PIC32MZ Graphics (DA) Family

PIC32MZ Graphics (DA) Family Silicon Errata and Data Sheet Clarification

The PIC32MZ Graphics (DA) family devices that you have received conform functionally to the current Device Data Sheet (DS60001361E), except for the anomalies described in this document.

FIGURE 1: Posc CRYSTAL CIRCUIT

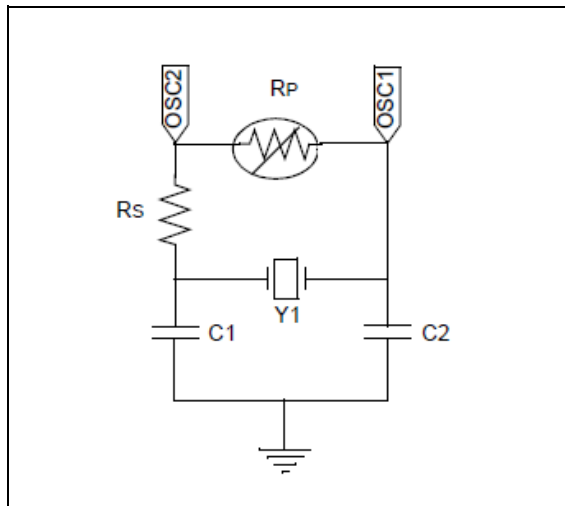
1. Module: Primary Oscillator

The POSC has been tested in a normal power-up sequence and supports specific crystal operation.

The Primary Oscillator (Posc) has been characterized to operate at 8 MHz and 12 MHz when the circuit shown in Figure 1 is implemented, and the operating conditions listed in Table 3 are met.

Crystal Frequency (See Note 1)	Series Resistor Rs	Posc Gain Setting POSCGAIN<1:0> (DEVCFG0<20:19>	Posc Boost Setting POSCBOOST (DEVCFG0<21>
8 MHz	2 kΩ	'0b00 (GAIN_0)	'0b1
12 MHz	1 kΩ	'0b00 (GAIN_0)	'0b1

FIGURE 2: EXTERNAL RESET CIRCUIT

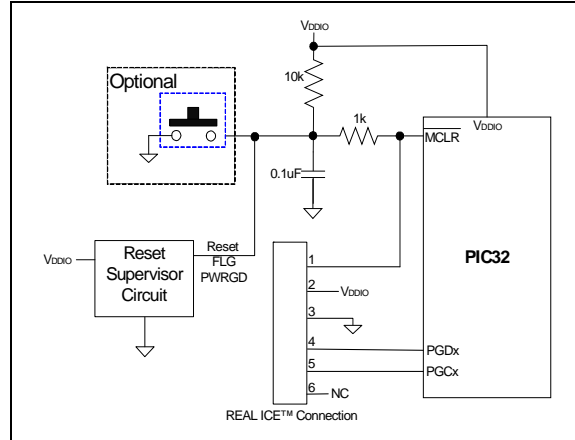
3. Module: Reset

A system Reset is not generated on a BOR event ($V_{PORIO} < V_{DDIO} < V_{BORIO}$). This will stop system clocks with all the I/O pin functions frozen in the present state until either V_{DDIO} falls to V_{PORIO} or $V_{DDIO} > V_{BORIO}$.

Reset device using a \overline{MCLR} pin through an external reset supervisor/monitor is shown in Figure 2. Set the SMCLR (DEVCFG2<15>) configuration bit to '0', which makes the \overline{MCLR} to act as a POR Reset instead of a normal system reset.

- Minimum Reset trip voltage of the external supervisor should be $V_{BORIO} (Max)+0.5V$.
- The external reset supervisor/LDO output going to \overline{MCLR} should have an open drain output to not interfere with the MPLAB programming/debug tools.

When this work around is implemented, the minimum V_{DDIO} operating voltage of the application needs to be above the reset supervisor maximum trip voltage + 0.2V, where 0.2V compensates for variation in the external reset supervisor voltage.
